Outside Door Weatherstrip - Multiple Concerns

YEAR(S)	MODEL(S)	ADDITIONAL INFORMATION
2013 – 2014	FR-S

Some 2013 – 2014 model year FR-S vehicles may exhibit multiple concerns from the Outer Weatherstrip (belt molding).

Figure 1.

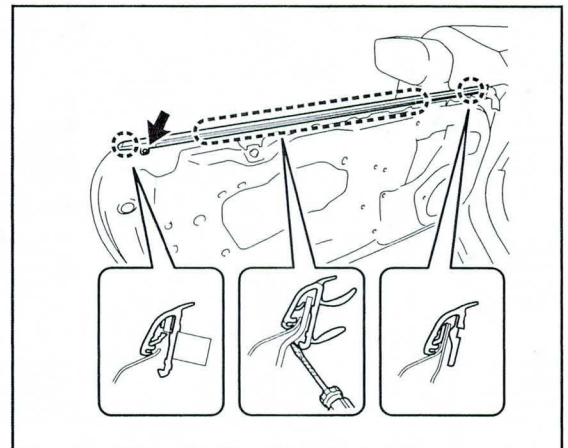
6. Remove front door glass Outer Weatherstrip assembly.

- A. Remove the screw.
- B. If necessary, use a screwdriver to disengage the claw and remove the front door glass Outer Weatherstrip assembly.

Figure 2.

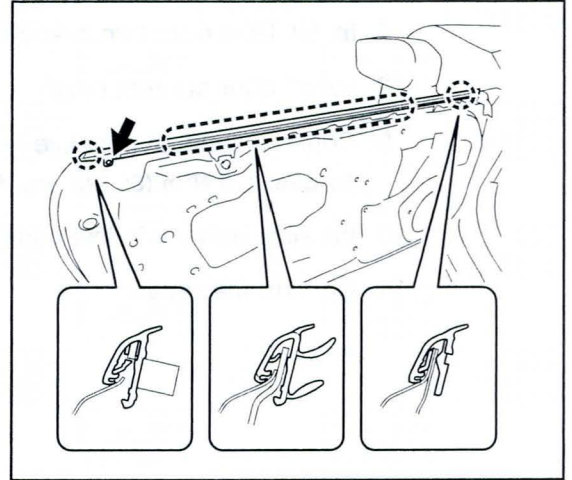
2. Install front door glass Outer Weatherstrip assembly.

Engage the claws to install the screw and a NEW front door glass Outer Weatherstrip assembly as shown.

Ensure proper installation of Outer Weatherstrip by confirming that the claw attached to the weatherstrip is fully engaged.
